ORIGINATION FORM

Proposed Revisions to a Standard Plans Index
(Please provide all information — Incomplete forms will be returned)

Index Number: 536-001
Sheet Number (s): 6, 7, 9, and 17
Index Title: Guardrail

END TREATMENT - TRAILING ANCHORAGE

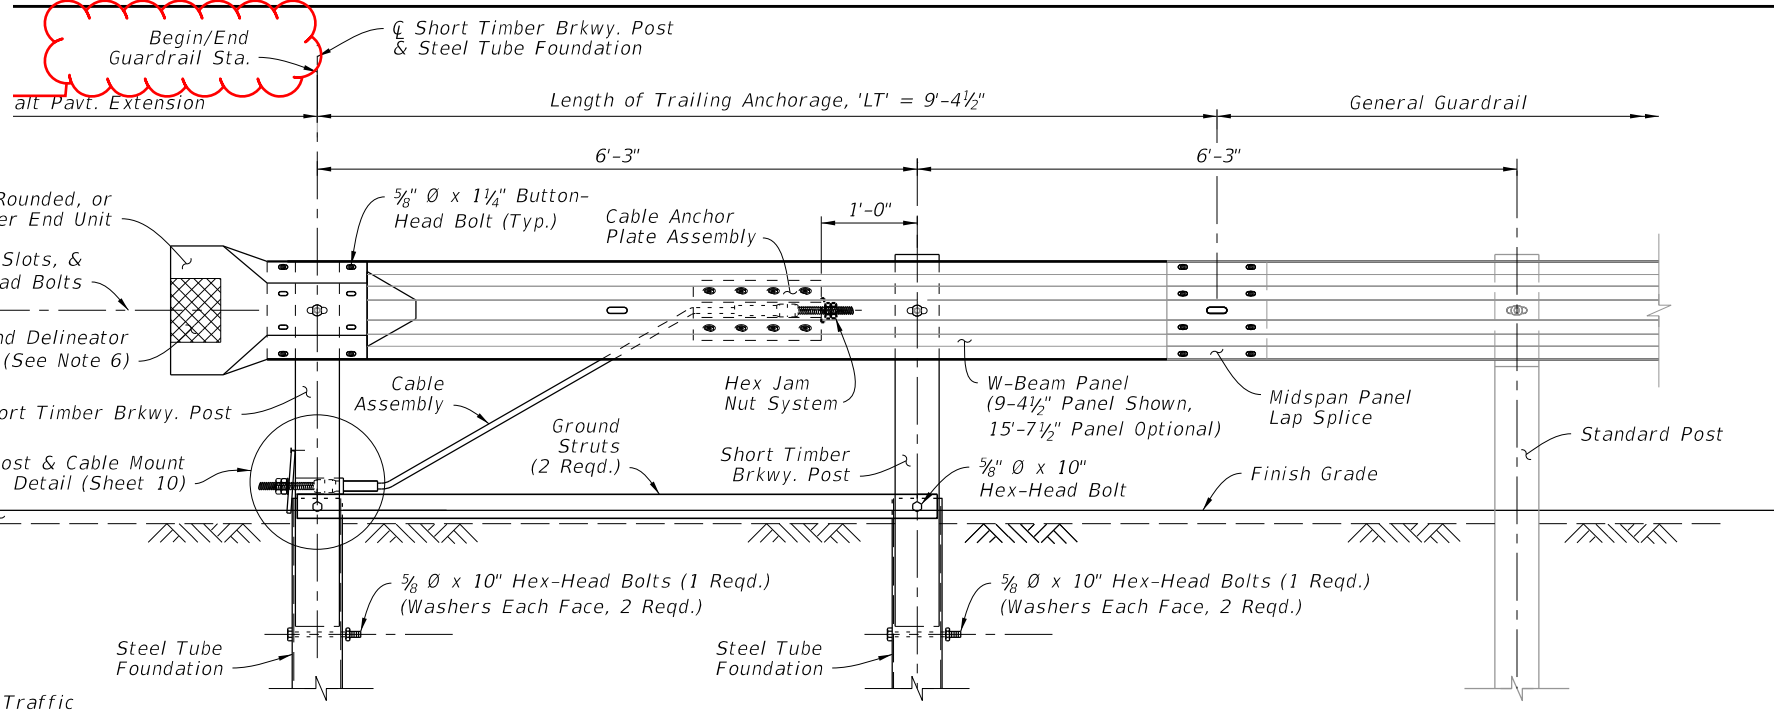
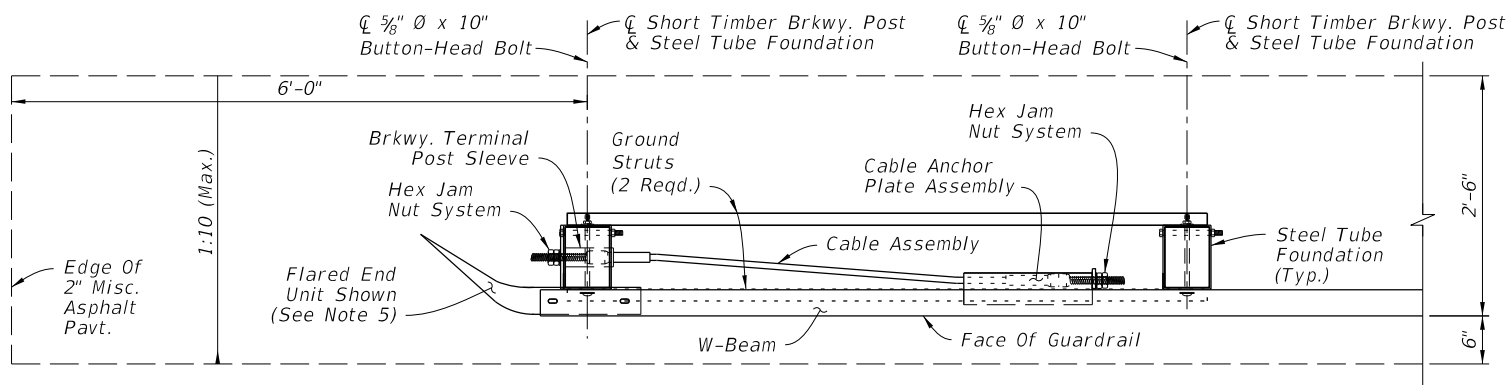
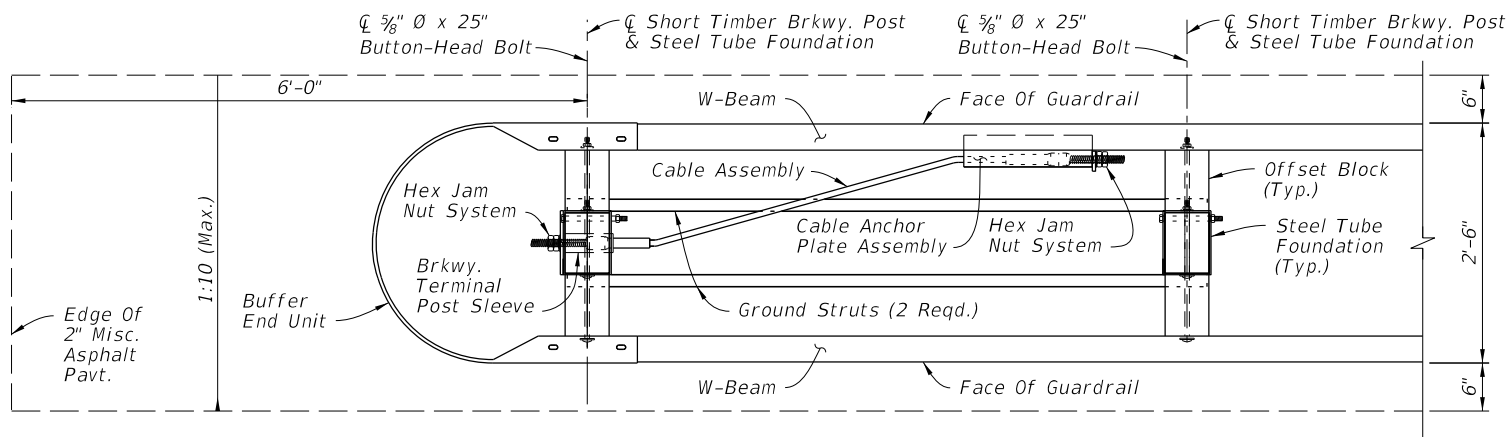
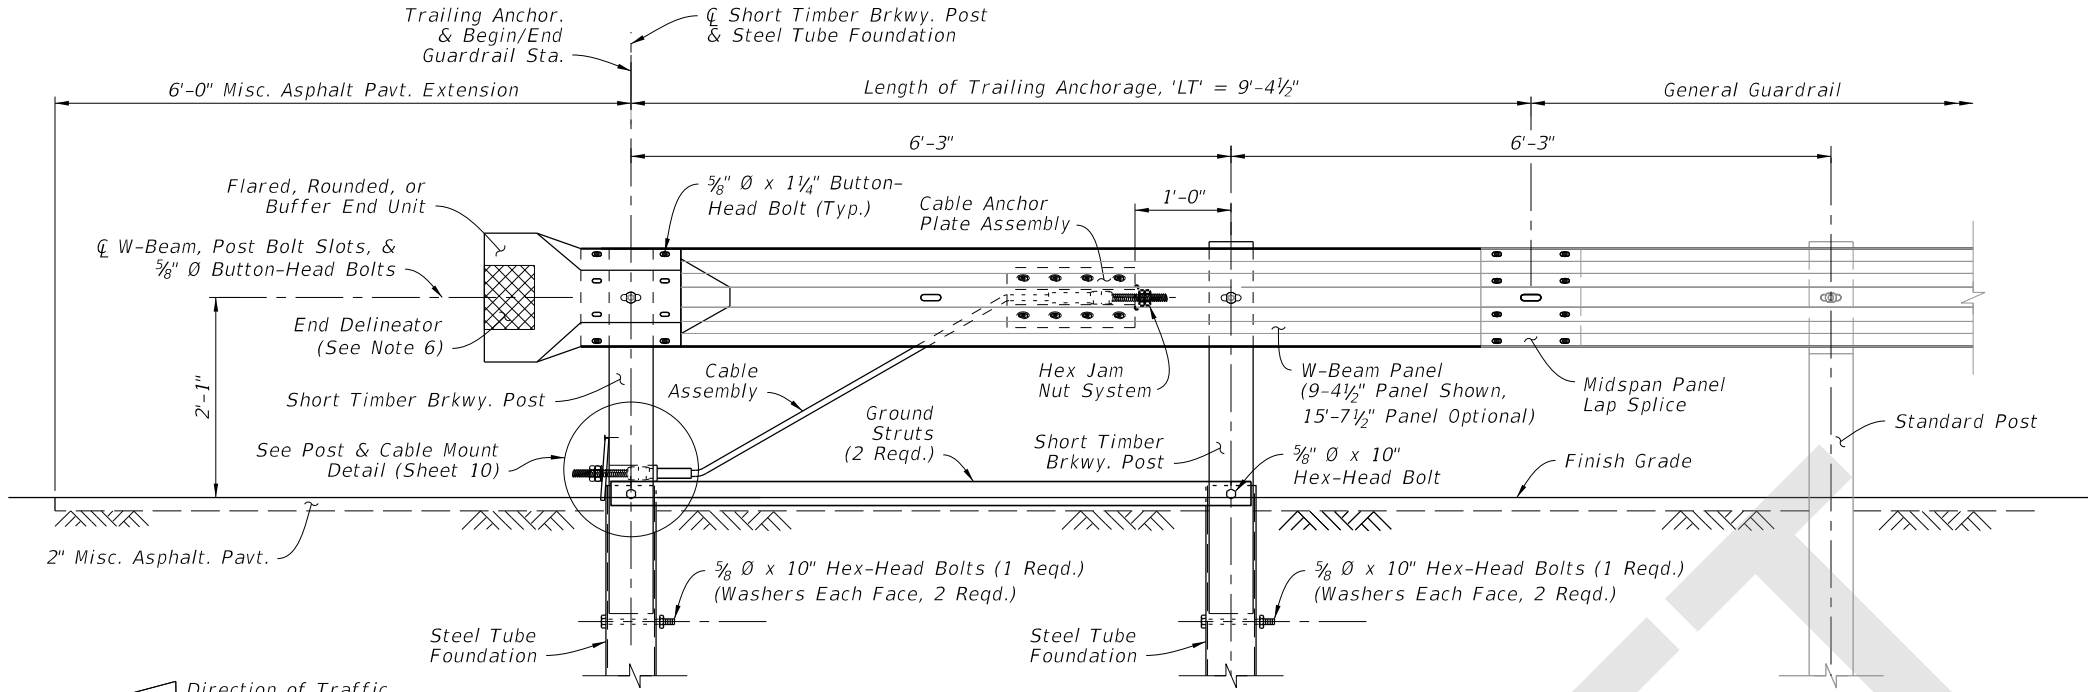
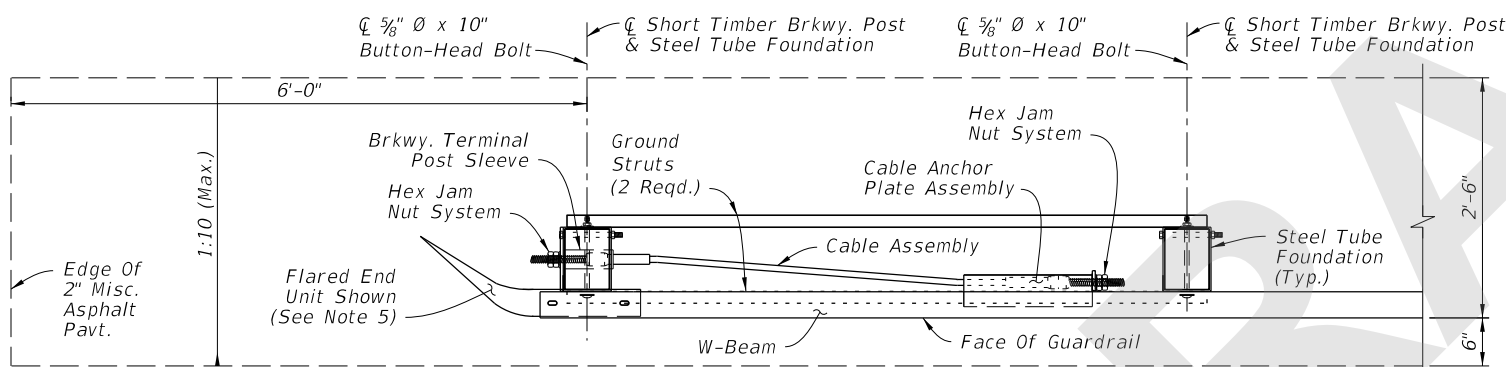
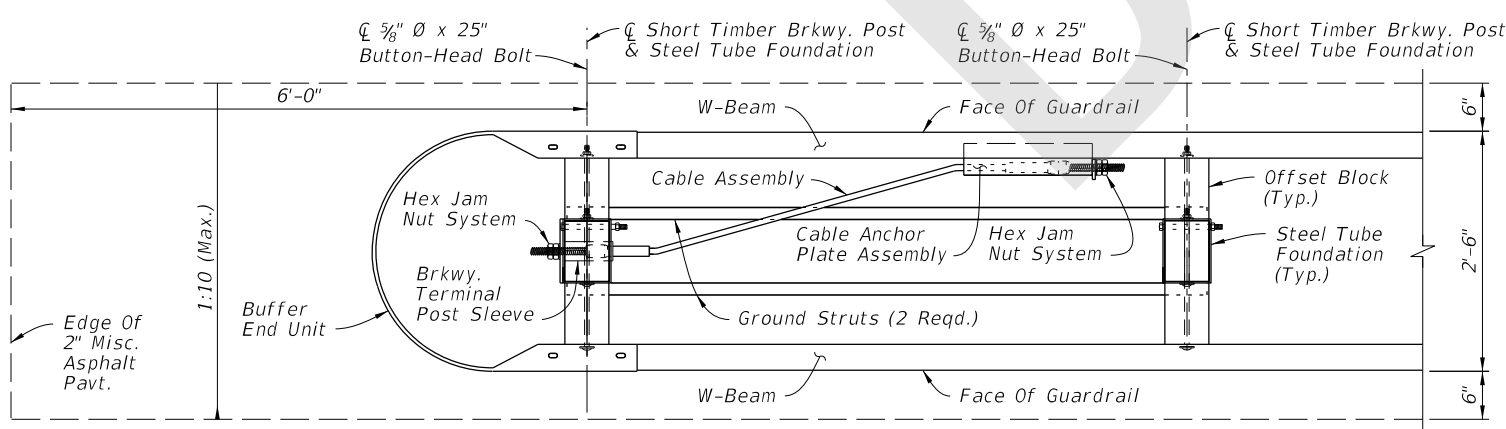
Sheet 9: Add Trailing Anchor. Sta. callout at post 1

Added Trailing Anchorage Callout Station for Consistency with Plans and Other Segment Callouts

SECTION A-A RIGID BARRIER TERMINAL CONNECTOR MOUNT

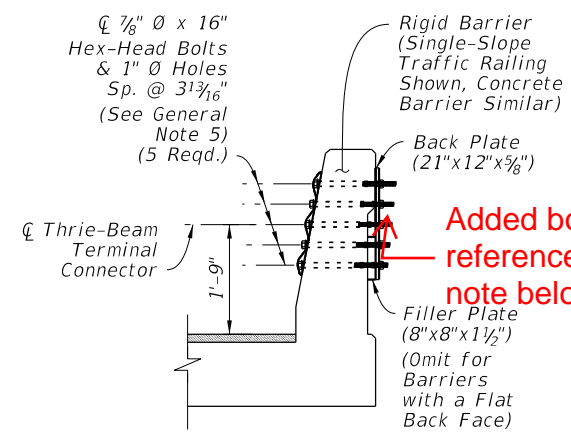
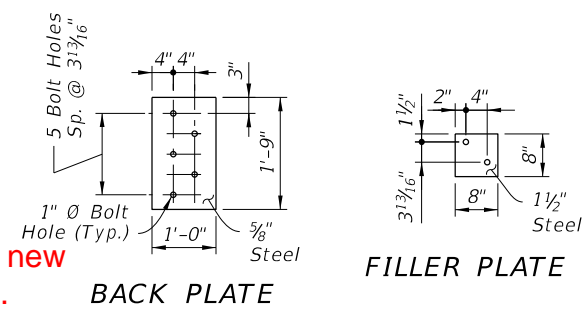
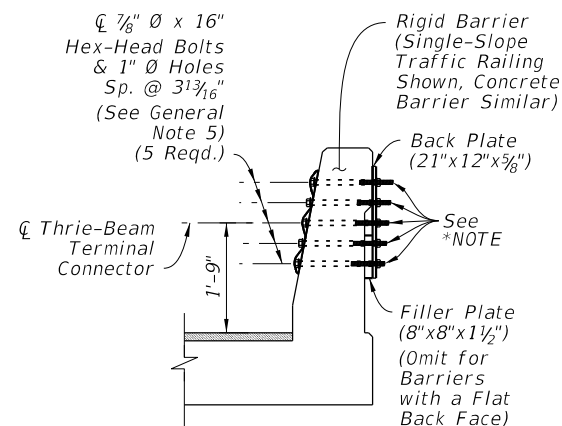
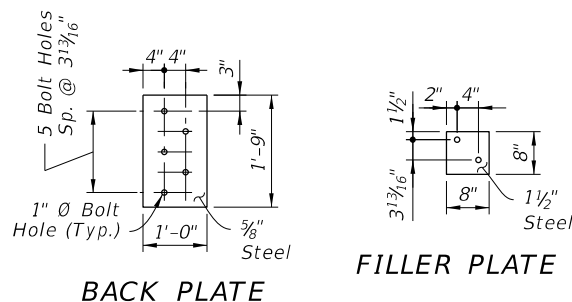
Sheet 17: Added additional notes to guardrail bolt connection to concrete rigid barrier in order to accommodate nearby sidewalk or shared use path.

Added bolt reference to new note below...

Added note to accommodate nearby sidewalk or shared use path

*NOTE: For locations within 4'-0" of a sidewalk or shared use path, trim bolts down to within 1/4" of tightend nut. Deform exposed threads. File down sharp edges and burrs.
